CITY OF CHARLOTTESVILLE

RE: 0 E High Street Preliminary Site Plan 1st Submittal Comments

Sheet C1

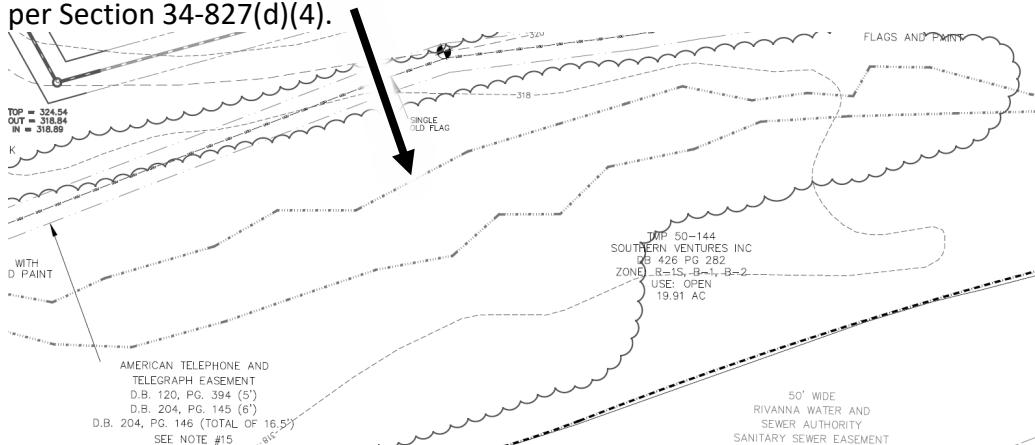
16. (P) The City's Zoning Map designates a portion of TMP 50-144 as Central City (CC) Mixed Use Corridor District, as shown above. Please update the *Zoning* section to reflect all zoning categories per Section 34-827(d)(1).

17. (P) The *Building Height* section references Section 34-457(b)(5), which provides requirements for the Industrial Corridor (IC) Mixed Use Corridor District. No property within the development is currently zoned IC. Please update reference per Section 34-827(d)(2).

18. (P) Please update the *Building Setbacks* section to provide the actual required side setback per Section 34-457(b)(2) based on the proposed maximum building height per Section 34-827(d)(1).

19. (P) Please update the *Proposed Use* section to include the Rivanna River Company use per Section 34-827(d)(2).
20. (P) Please update the *Proposed Use* section to indicate residential units are multifamily and provide the number of units for based on bedroom count (number of 1-bedroom units, number of 2-bedroom units, etc.) per Section 34-827(d)(2).

21. (P) Multifamily residential units are not permitted in the R-1S portions of the project and any land zoned R-1S is not used in the determination of DUA. Per Section 34-

827(d)(2), please update the *Proposed Use* section to indicate the acreage of each zoning district and provide DUA based on area of zoning districts which permit multifamily residential units (zoned B-1, B-3, and CC).

22. (P) Per Section 34-827(d)(2), please update the *Parking Schedule* section to indicate the proposed number of compact parking spaces and overall percentage of compact parking spaces to demonstrate compliance with Section 34-977(b)(2).
23. (P) Per Section 34-827(d)(2), please update the *Parking Schedule* section to indicate required and provided parking spaces for the Rivanna River Company per Section 34-984.
